Subject: PROPOSED RESOLUTION OF ISLOCA ISSUE FOR ABWR

Enclosed is the subject document including modified P&IDs for the affected systems. Following NRC staff review and approval of the proposed ISLOCA resolution, GE will prepare a corresponding modification to Subsection 19B.2.15, High/Low Pressure Interface Design.

PROPOSED RESOLUTION OF ISLOCA ISSUES FOR ABWR.

FIGURE 1

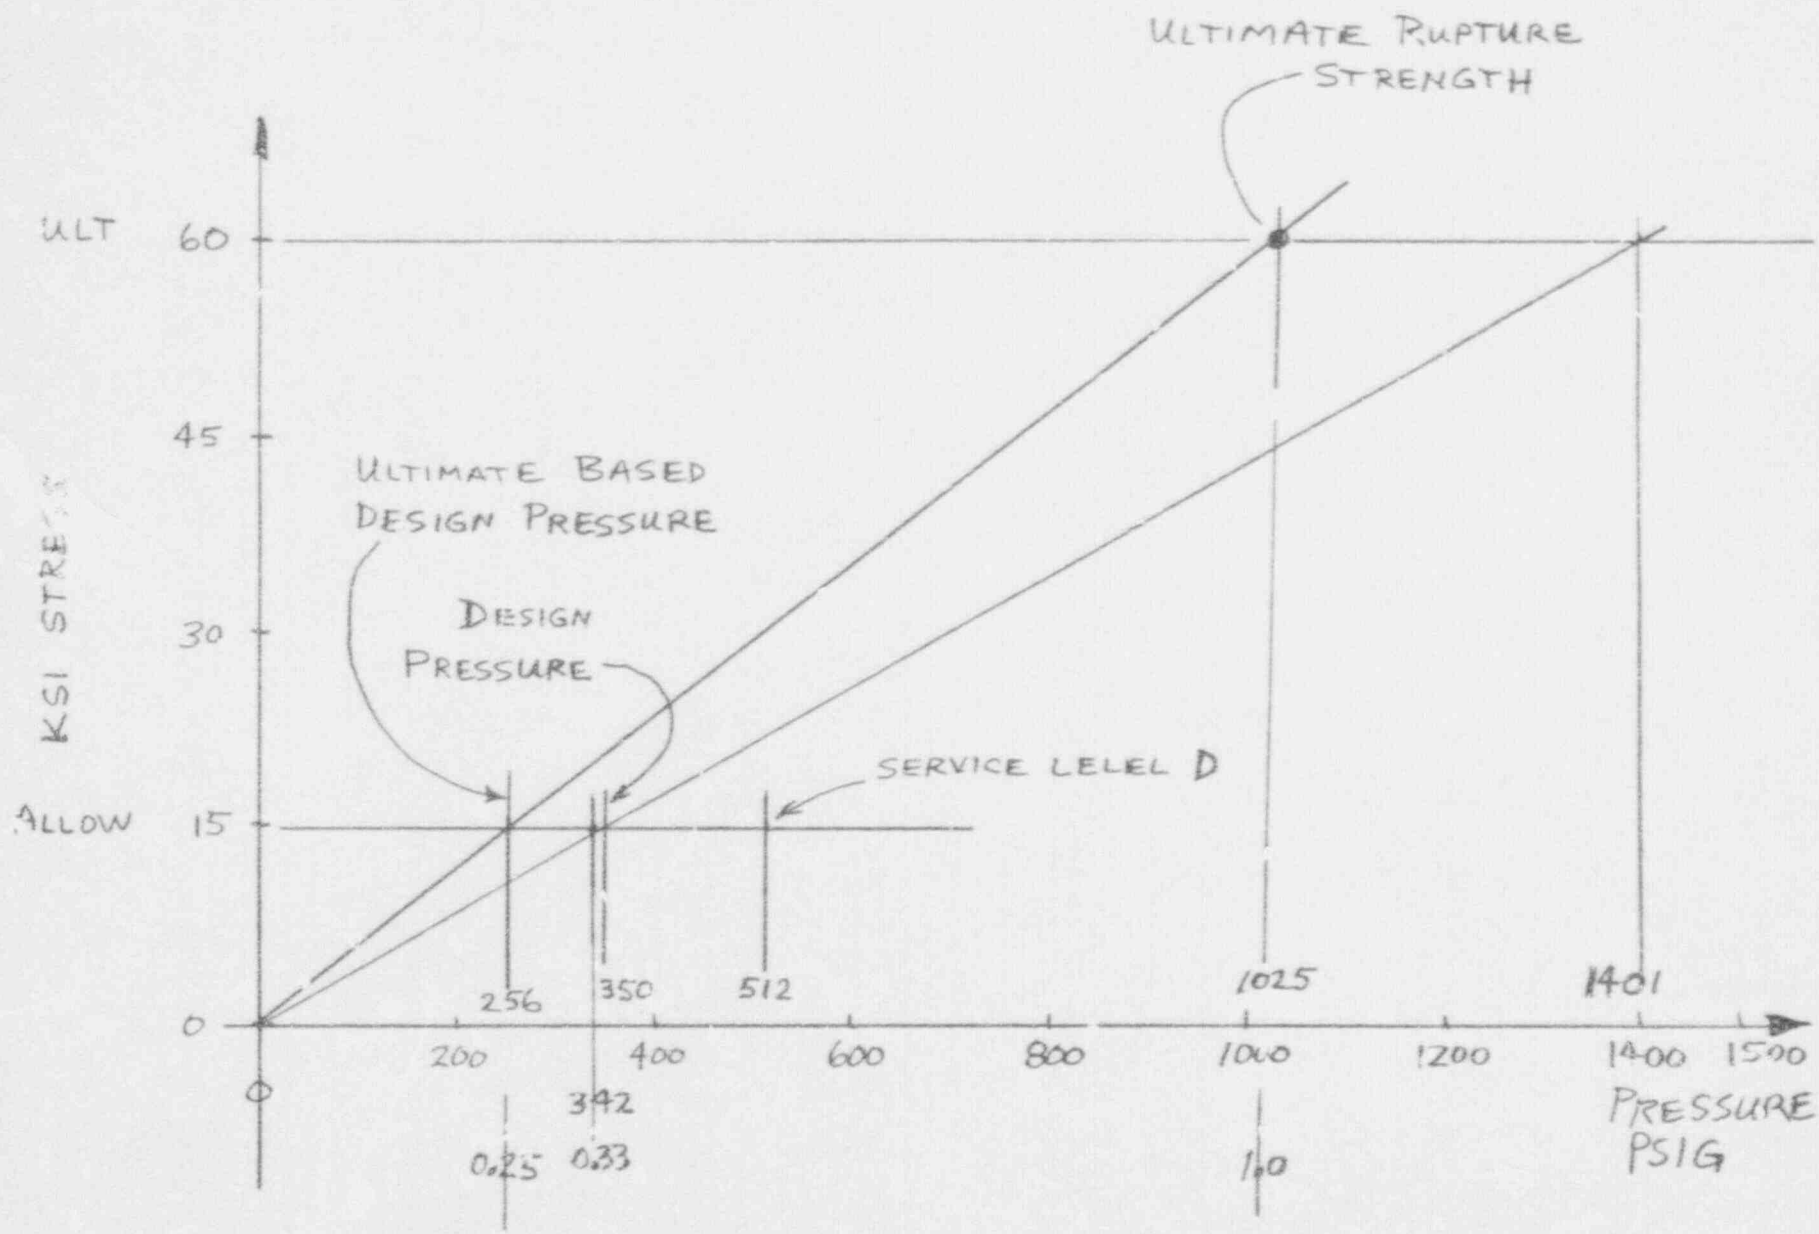
The full URS condition is illustrated on Figure 1 at the full reactor pressure of 72.1 atg, 73.1 ata (1025 psig; 1040 psia) and the ultimate stress. The straight line from this point to the coordinates origin establishes

proportionality to the URS, which is valid since pressure and stress are proportional. Using an example of carbon steel with an ultimate stress of 4219 kg/cm^2 (60 kpsi) and an allowable stress of 1055 kg/cm^2 (15 kpsi), the ultimate based design pressure proportional to the allowable stress is 18 atg (256 psig). Thus for a pipe designed so that a 18 atg (256 psig) pressure produced the allowable 1055 kg/sq cm (15 kpsi) stress, then if an over pressurization of 72.1 atg (1025 psig) occurred in that pipe, its stress would rise to 4219 Kg/cm^2 (60 kpsi), the ultimate strength. Thus, 18 atg (256 psig) represents an ultimate based design stress that has no margin with respect to the URS.

In this case the ratio of allowable stress to ultimate stress is $15/60 = 0.25$, which is the same as the ratio of design pressure to applied pressure, $256/1025 = 0.25$. To use a design stress that has a reasonable margin with respect to the full URS, a ratio of 0.33 is utilized instead of 0.25. A ratio of 0.33 produces a design pressure of 24 atg (342 psig), which when nominally rounded up gives a 24.6 atg (350 psig) design pressure. For a pipe designed just for the 24.6 atg (350 psig) design pressure, an applied pressure of 98.5 atg (1401 psig) would be necessary to reach the full ultimate stress of 4219 kg/cm^2 (60 kpsi).

The safety factor is 1.00 at the "ultimate based design pressure," see Figure 1, with a design pressure of 256. The selection of the 24.6 atg (350 psig) design pressure resulted in a safety factor of 1.367, which was considered a placement to the extent practical within the range between the ultimate based design pressure (S. F. = 1.00) and the Code service level D (S. F. = 2.00).
